Technical Preservation Services  
Preservation Assistance Division  
National Park Service  
U.S. Department of the Interior  
Washington, D.C.

Interpreting  
the Secretary of the Interior's  
Standards for Rehabilitation

Volume III

5. Lobby and adjoining spaces after rehabilitation. The palm room and dining room have been subdivided. A new partition directly behind the decorative screen has destroyed the progression of spaces that marked the original design.

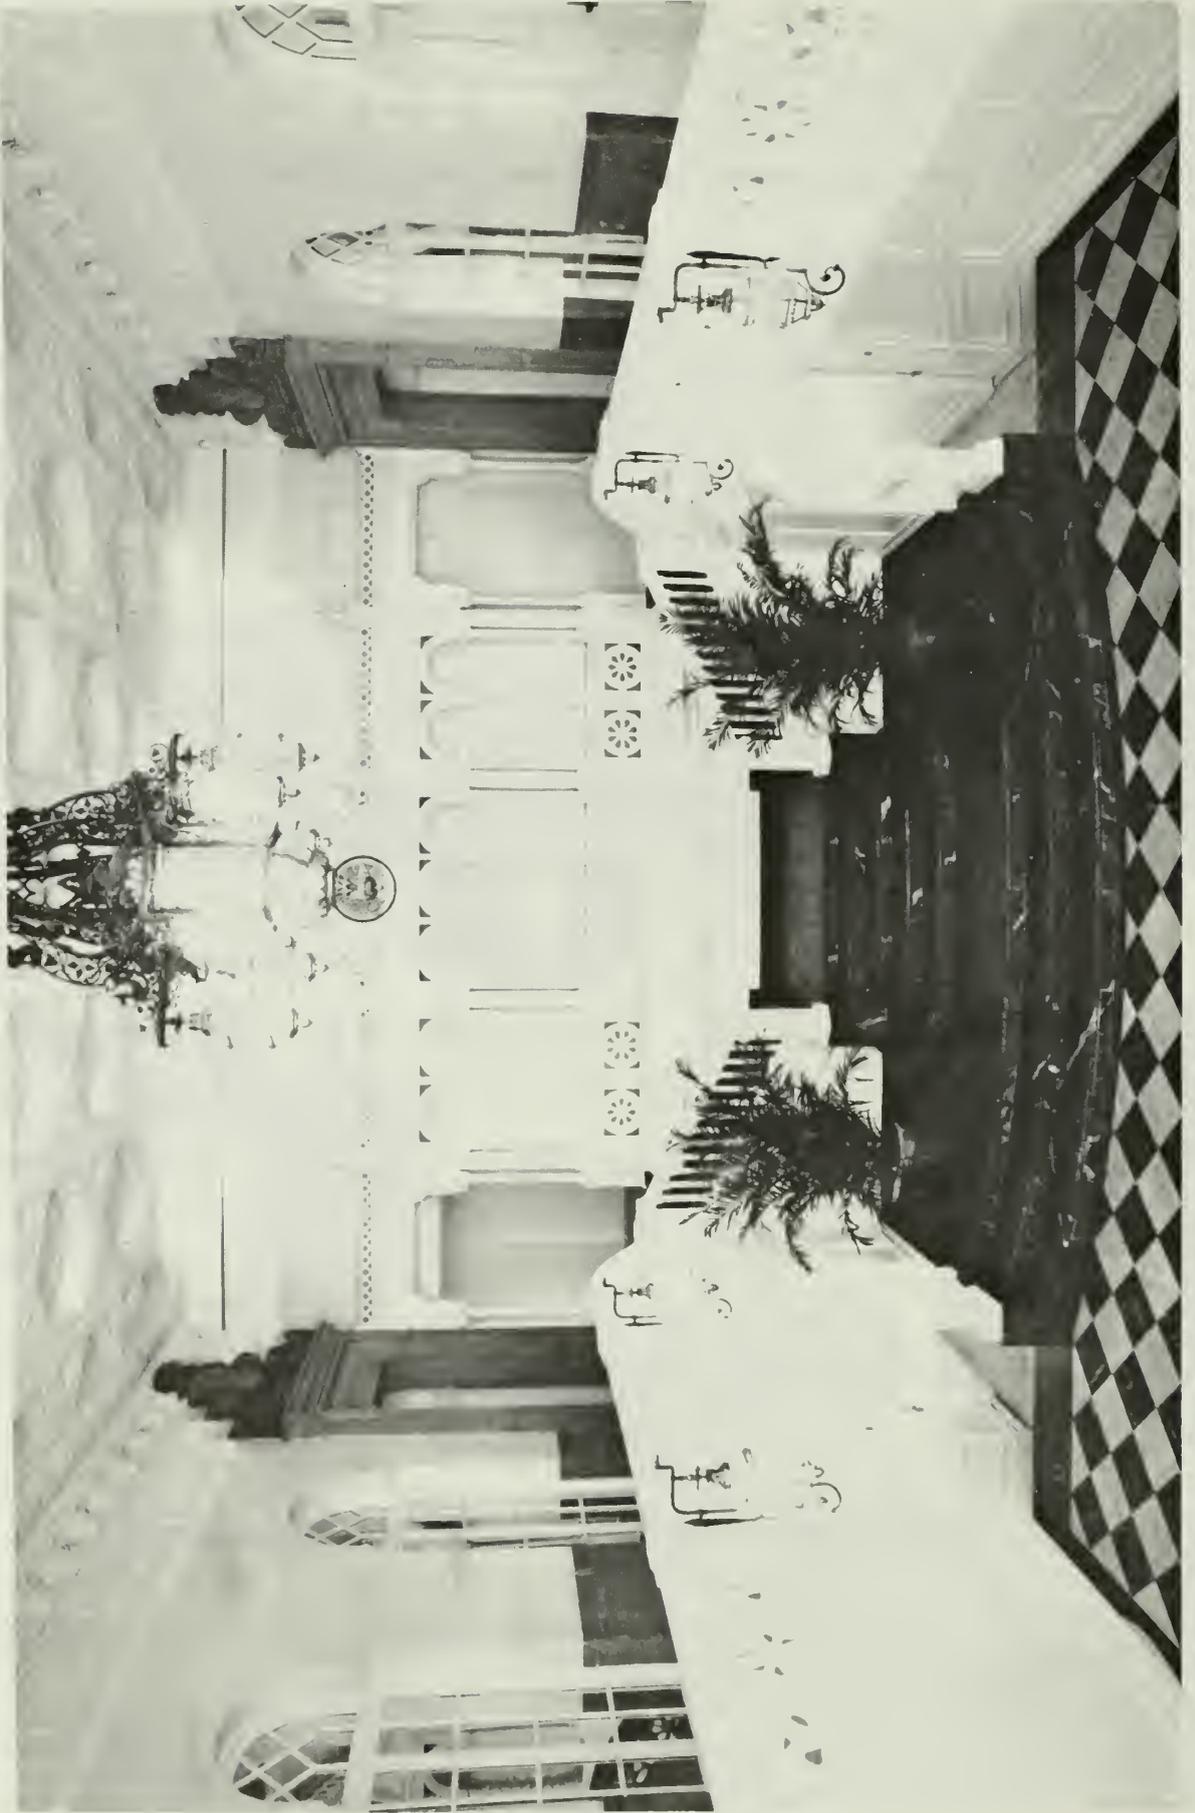
The project was determined not to meet the "Standards for Rehabilitation" on a number of grounds. In the palm room both the decorative finishes and the space itself were destroyed in the process of inserting two levels of residential space. In the dining room, individual features were retained, but in the finished work they appear as individual artifacts only, out of architectural context. The sense of the room as a coherently organized space is lost. These modifications to the two spaces had adverse effects on the historic character of the building, and alone would preclude the project from meeting the Secretary's Standards. When these spaces are viewed in relation to the overall layout of the building, however, the consequences caused by their subdivision appear even more serious.

The insertion of a solid partition behind the open screen effectively cut off the lobby from the palm room. The damage wrought by the rehabilitation to the individual spaces thus exceeded the demolition of individual features or their incorporation into smaller rooms. The rehabilitation destroyed the formal organization of the spaces themselves. The progression from the grand, three-story lobby, up the elaborate split stair into the palm room and adjoining dining room was lost, and the historic character of the building irreparably harmed.

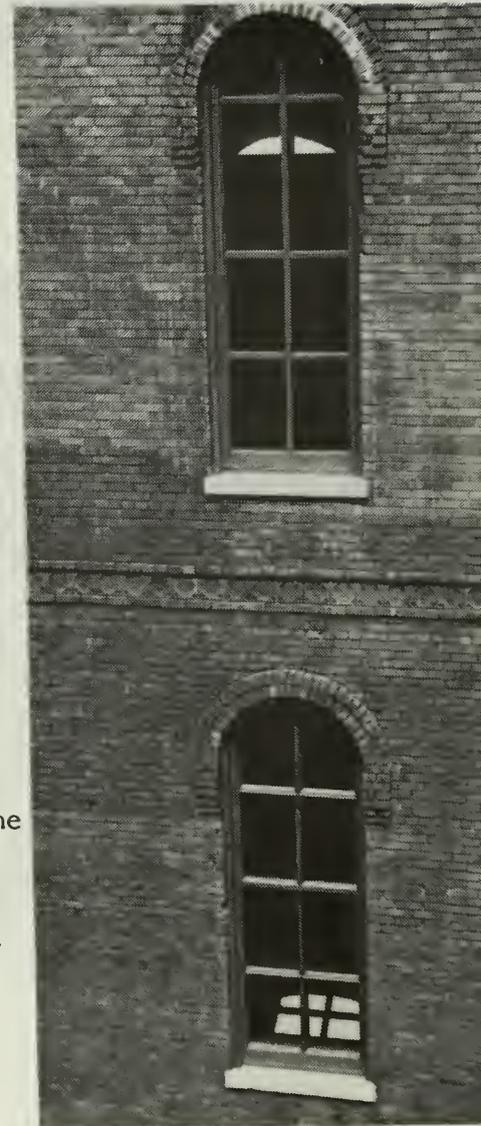
Before and after photographs revealed several design deficiencies in the new window. Where one over one double-hung windows had existed historically on the building's primary facade, the replacement windows were a "fixed" design with both upper and lower sash on the same plane; the horizontal piece applied as a meeting rail is actually flat, and consequently unable to cast the familiar shadow line of the historic window. Finally, there was a dramatic difference in color, from a light cream color to dark brown (see illus. 1 and 2). On another key facade, where there had been historic four-over-four double-hung windows, fixed sash were installed, the light divisions were altered, wider muntins were used, and the color of the windows was changed (see illus. 3, 4 and 5).

In view of the prominence of these windows, I do not believe that any superficial, cosmetic changes to the muntins--instead of replacing the existing sash and installing accurate replicas of the originals--can be made that would bring the project into compliance.

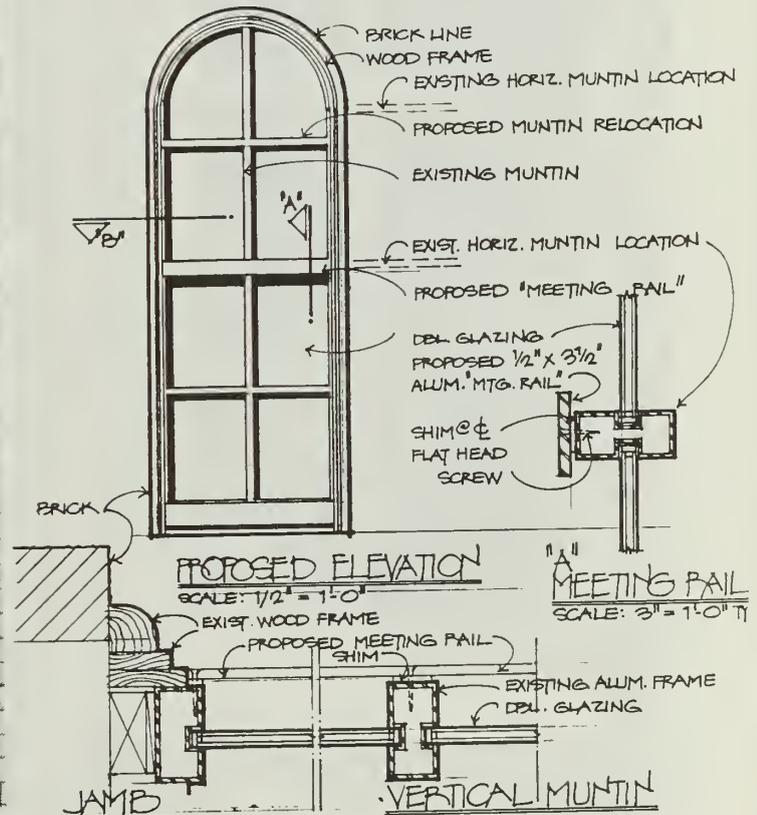
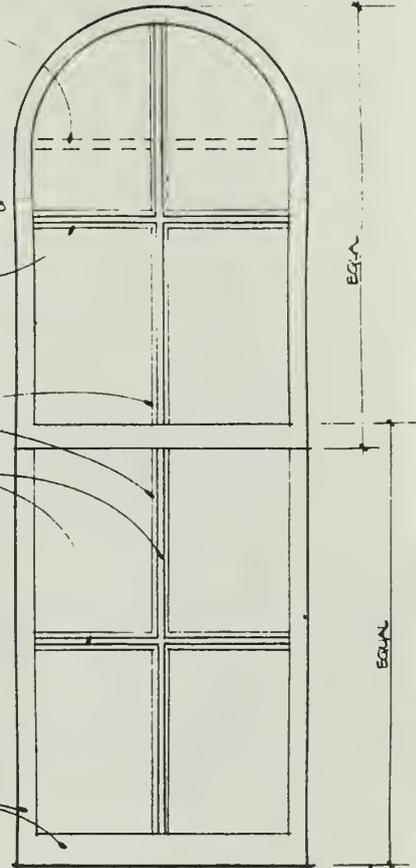
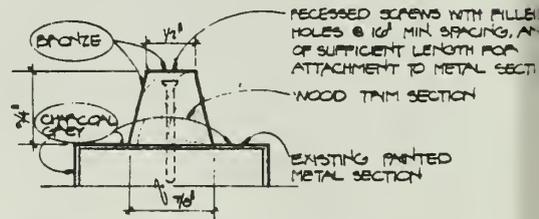
7. In alternative B, proposed changes included installation of a wood brick molding. In an attempt to make the muntin appear thinner and visually recessed, the wide aluminum muntins would be painted a charcoal gray; trapezoidal shaped wood strips would also be applied to the existing flat muntin and painted to match the existing window color. Even making these modifications, the replacement window did not match the detailing of the historic window--the depth of the frame and muntin was still far too shallow, and the muntin profile and width was still inappropriate. This proposal was also rejected.

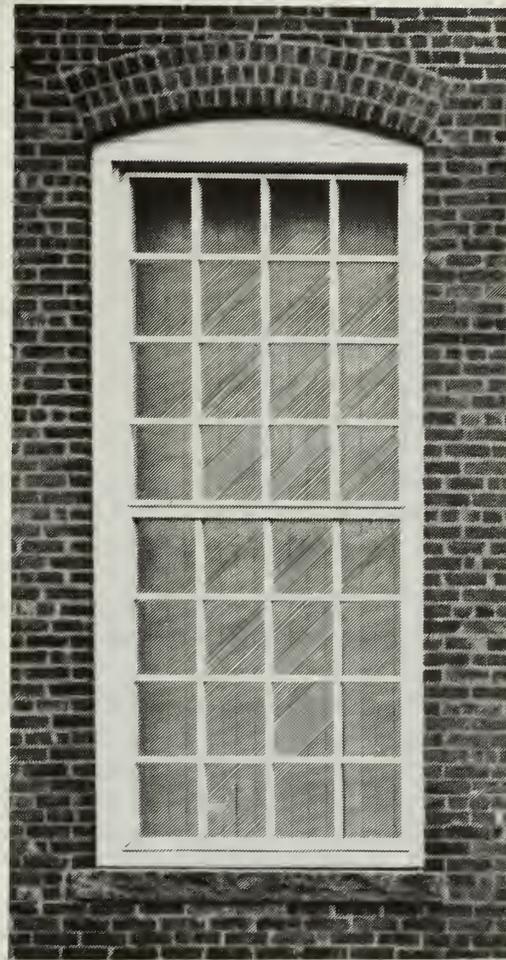
The replacement windows, however, did not adequately duplicate the visual qualities of the historic windows, specifically in appearance, shadow lines, muntin detail and planar qualities. In addition to the change from an arch-headed to a square-headed sash, a number of other distinct changes have occurred to the historic appearance of these windows. The double-hung, historic wood windows have been replaced by fixed metal units with much narrower sash dimensions, noticeably changing the planar relationship of the upper and lower sash. The resultant effect is that at certain angles the replacement windows have the appearance of the upper and lower sash being in the same plane, rather than duplicating the appearance of the historic, double-hung sash (see illus. 3-5).

The thickness of the meeting rail so evident in the historic sash has been reduced in depth creating a weaker shadow line (see illus. 5). The use of an applied aluminum muntin grid rather than true 16-over-16 wood muntin divisions has caused significant changes to the appearance of the windows (see illus. 6). The muntin grid clearly does not match the original, since the new muntins have a rectangular rather than trapezoidal profile, it has a ribbed surface, and it extends beyond the plane of the rails and stiles. The projecting grid, furthermore, creates additional shadow lines that did not exist on the historic windows. The historic muntins were flush to the surface of the sash, integral to the sash frame construction and trapezoidal in shape after puttying.

6. Proposed replacement window, exterior. Note rectangular panning, extensive subframe creating additional shadow lines. Compare the meeting rail and muntin dimensions with the historic sash in 4-5.

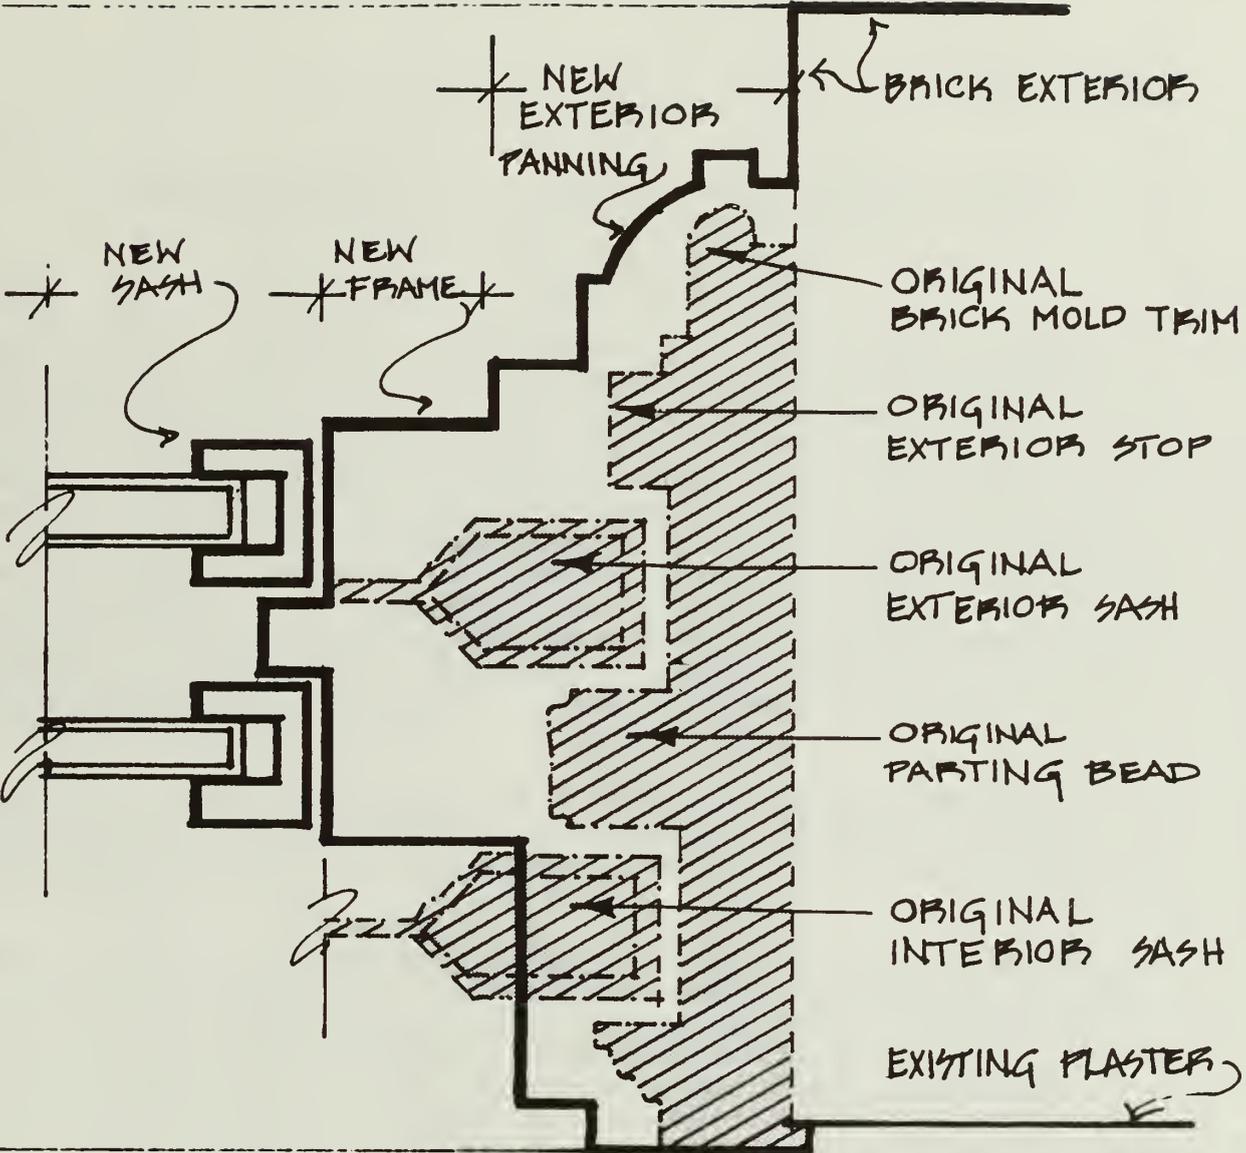
Aluminum, double-hung windows with attached metal grids on the exterior and interior to simulate muntins were chosen to replace the originals (see illus. 6-7). Several of these windows were installed to evaluate their effectiveness in matching the adjacent historic windows. These windows were, however, determined not to adequately duplicate the visual qualities of the historic windows in their color, proportion, size, and installation detail of the originals. A light ivory color was chosen, rather than the dark green of the historic sash, causing the windows to stand out against the facade rather than to recede as the dark-colored historic sash had done (see illus. 8). The new

2. The plan shows room size and arrangement; units converted to two-story spaces by cutting through the first floor are denoted by shadowing.

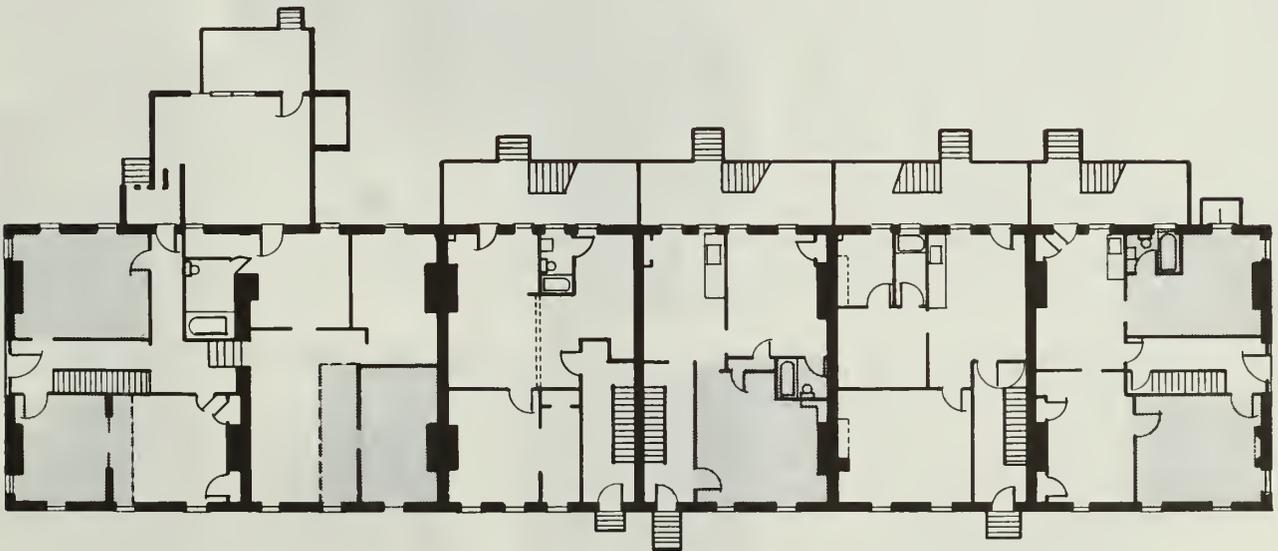
The rehabilitation was determined not to meet the Standards owing to the removal of large portions of the first floor in order to create two-story spaces that would permit additional light to rooms newly inserted in the basement. The change radically altered the historic spatial definition of these rooms as well altering the historic relationship of the first and primary floors to other floors in the buildings. This work was totally incongruous with the simple, but distinct historic character of the 19th century residential structures. In a denial letter to the owner, NPS explained further that the continued residential use of these buildings should not have posed any major problem or need for extensive changes to the building's overall historic design:

An alternative to removing portions of the floor would have been to regrade at the rear to permit more light to enter the basement through enlarged windows. It was further noted by NPS that the incompatible spatial changes were all the more regrettable because they were not essential to a viable reuse scheme for the buildings or to extending their useful life.

3. New stair after rehabilitation. Design of stair was not based on historic evidence.

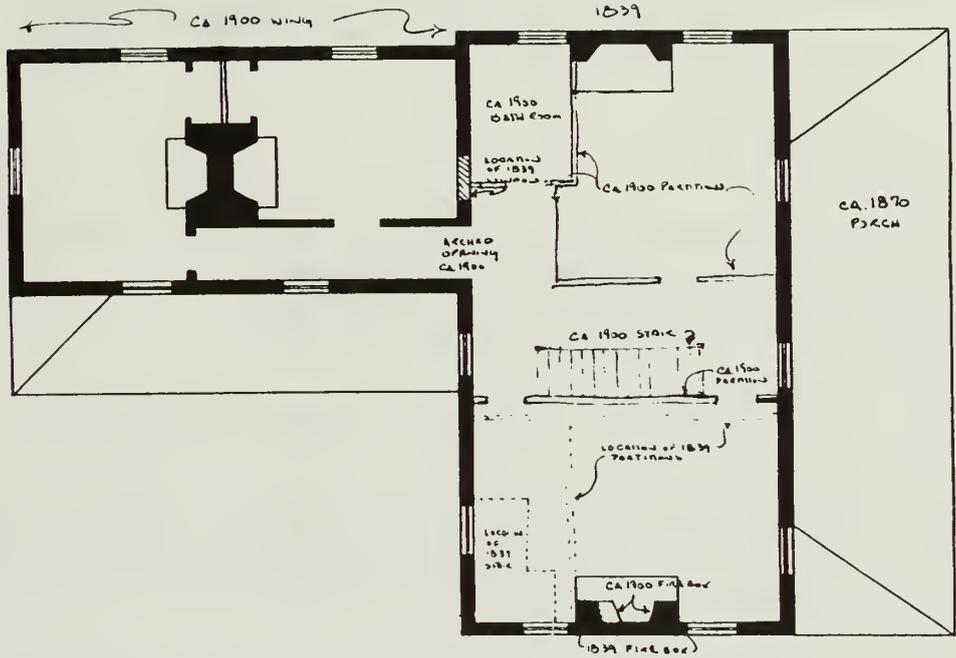
Any of these situations can provide useful clues necessary to carry out an accurate reconstruction of the lost element. However, reconstructions that are not based on such physical or documentary evidence, but merely on hearsay or a theoretical design, cannot be verified historically, and generally are not in accordance with the Secretary's Standards. If, during rehabilitation, some indication of a missing feature is encountered, unless adequate documentary evidence exists to guide an accurate reconstruction, it is better not to attempt such a treatment, but instead to design a replacement that is new but also compatible with the historic building. It is also important to remember that later additions or replacements for the earlier feature may have acquired significance over time; if so, they should be retained. Furthermore, if missing architectural elements are restored on a selective basis, the completed building may take on an appearance it never had historically.
